Groundwater Application Review Summary Form

Application # G- 18519 (Re-review)

PUBLIC INTEREST REVIEW FOR GROUNDWATER APPLICATIONS

TO: Water Rights Section Date 5/9/2019
 FROM: Groundwater Section Joe Kemper
 SUBJECT: Application G- 18519 Reviewer's Name
Supersedes review of 7/17/2018

Figure 2. Amended Well Location Map

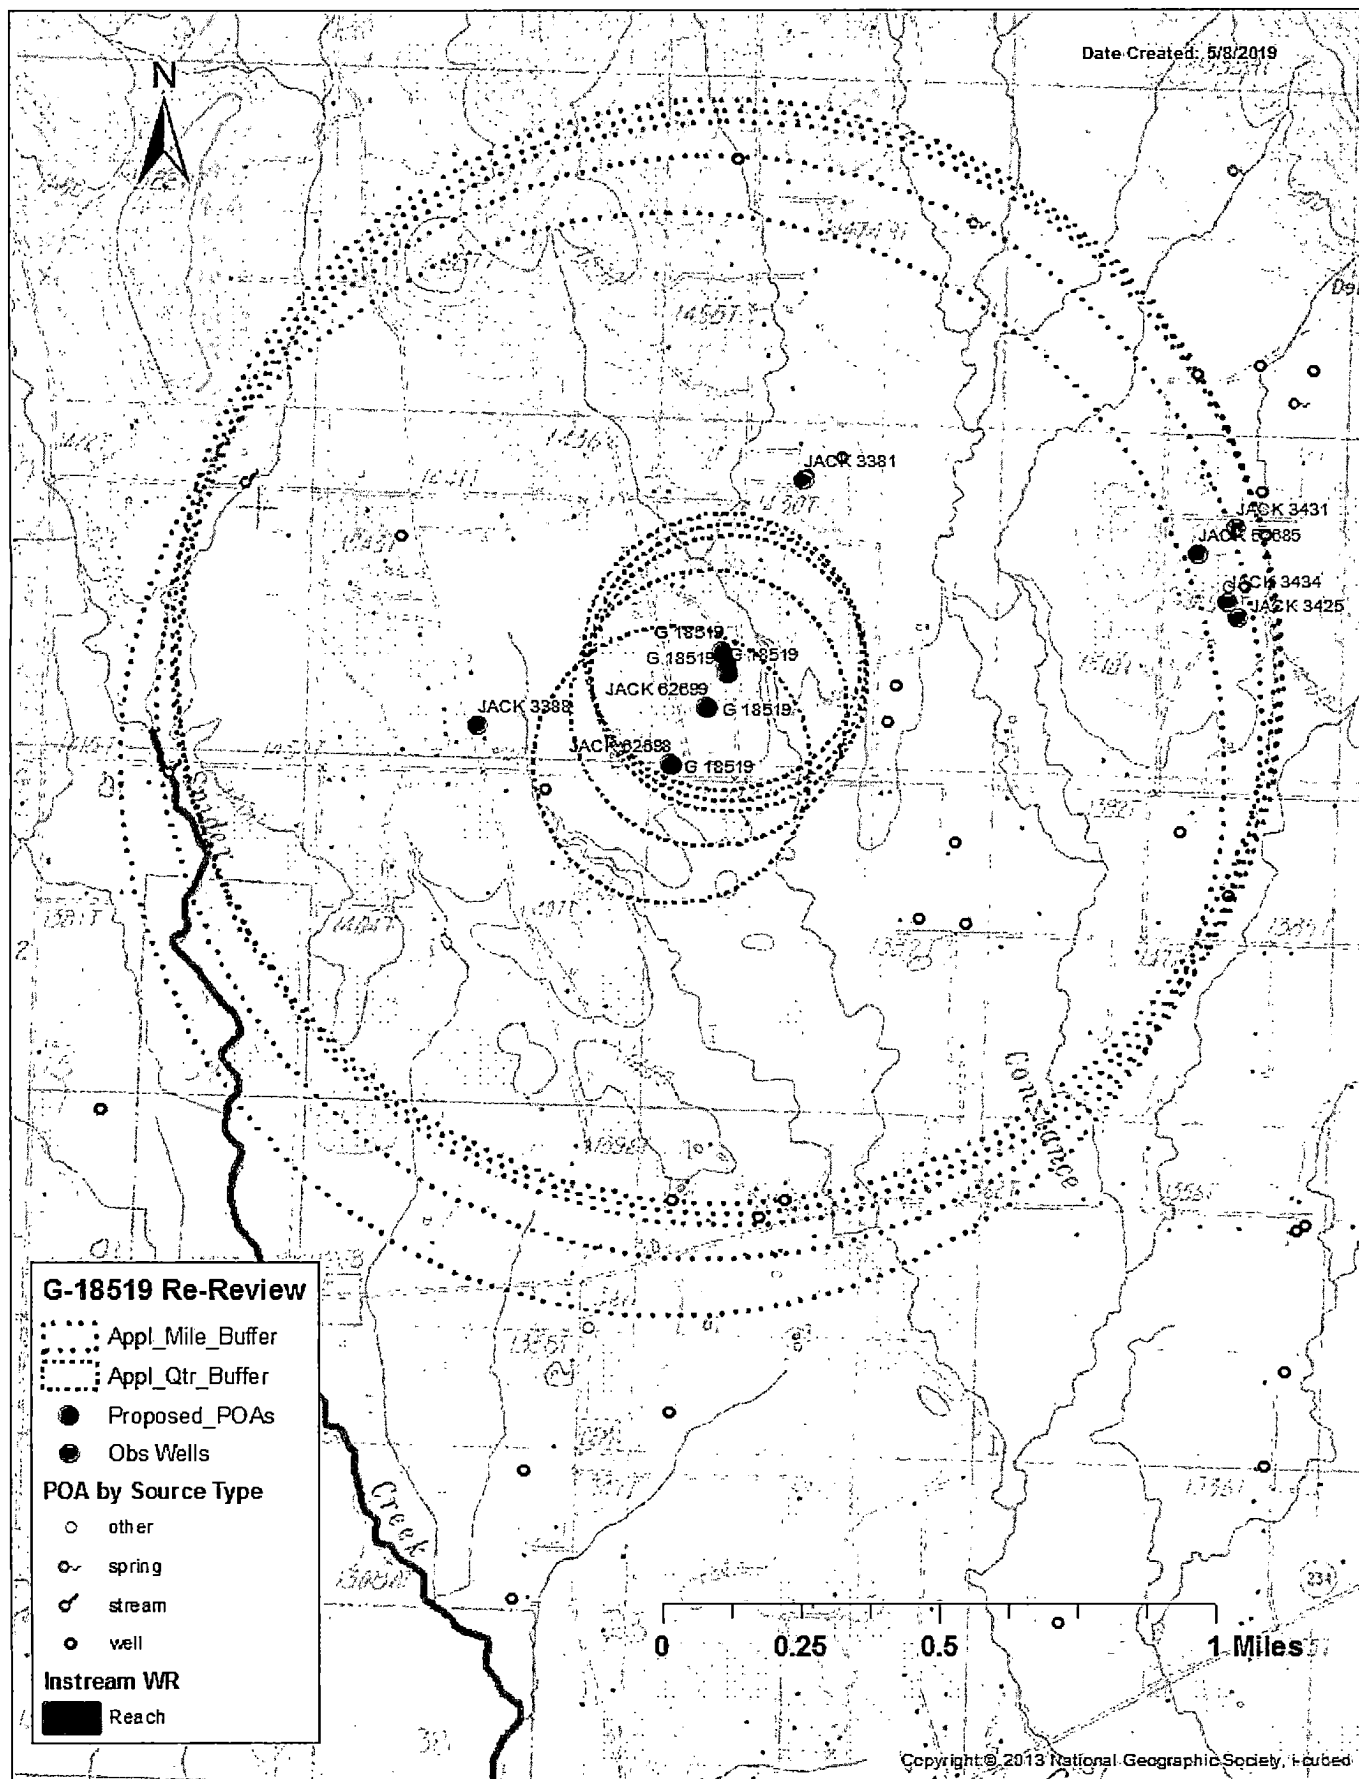
The proposed locations for Wells 3, 4, and 5 are very close together. It is noted that this proximity will likely cause well-to-well interference and could inhibit the production of these three wells.

Figure 3. Water-Level Trends in Nearby Wells

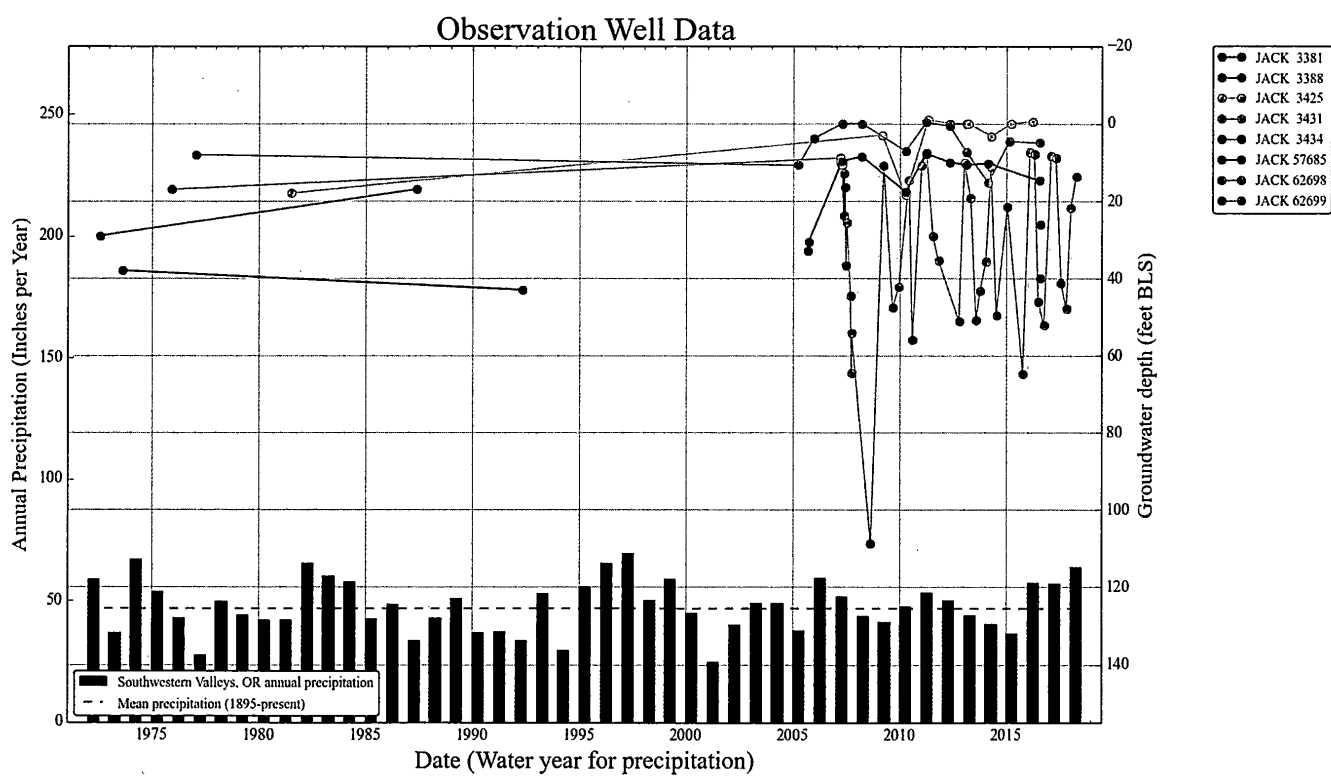
- B3. **Groundwater availability remarks:** The applicant's proposed POAs will be producing from fractured bedrock of the Payne Cliffs Formation. Wells in this aquifer system typically produce less than 50 gpm. There are no current OWRD observation well data within 1 mile of the proposed POA so aquifer over-appropriation cannot be determined. However, a cluster of observation wells accessing the Payne Cliffs Formation 1-2 miles to the east shows relatively stable water levels over the previous 10-20 years (see Figure 3).

There are several valid POAs within 0.5 miles of the applicant's wells, posing the risk of injury to senior water rights. However, adjacent taxlot density (as a proxy for well development) is moderate and the Department is unaware of any historic interference problems. Similarly, the above mentioned cluster of observation wells has similar development density, and water levels do not show systemic decline. As such, it is unlikely that the proposed use at the rate requested will cause injury to adjacent senior users.

Figure 4. Stream Depletion Model

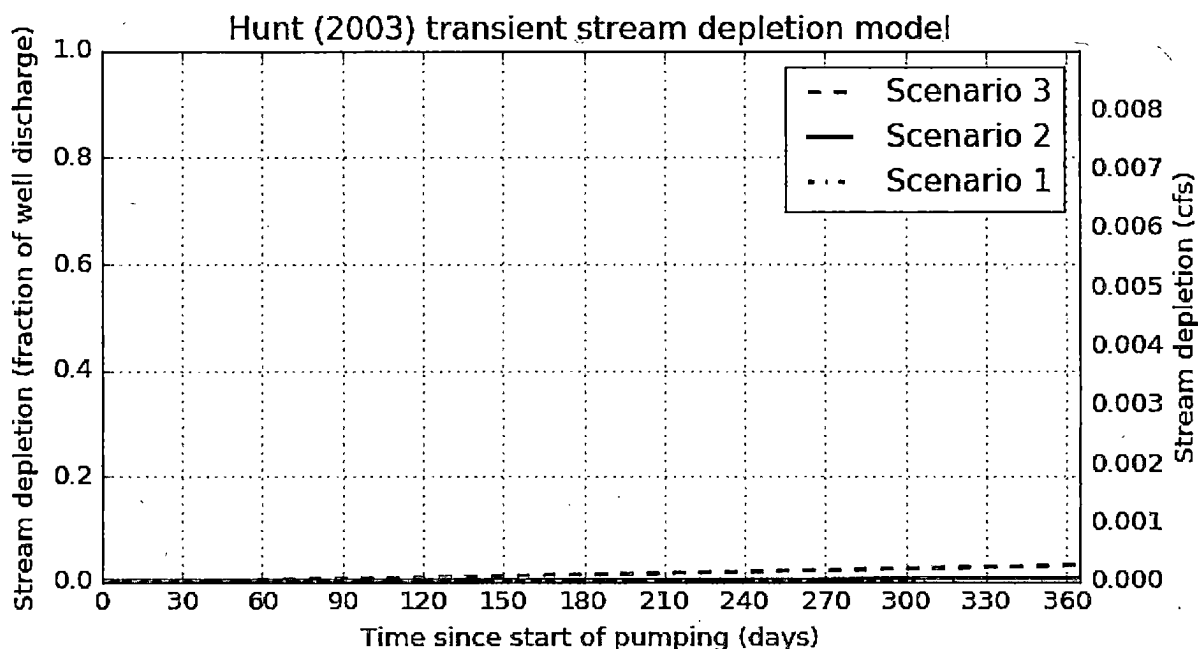
Comments: Pumping effects on adjacent surface water sources are evaluated using the Hunt (2003) stream depletion model with aquifer parameters representative of the local geology. Model parameters and results for the closest well-surface water source combination are presented in Figure 4.

In the amended application, the applicant has requested 0.009 cfs from Wells 1 and 2. If both wells can individually and instantaneously pump at 0.009 cfs (i.e., 0.018 cfs total), it will trigger a finding of PSI as per OAR 690-009-040 (4). Permit language must clearly state that the maximum instantaneous rate for Wells 1 and 2 combined cannot exceed 0.009 cfs.
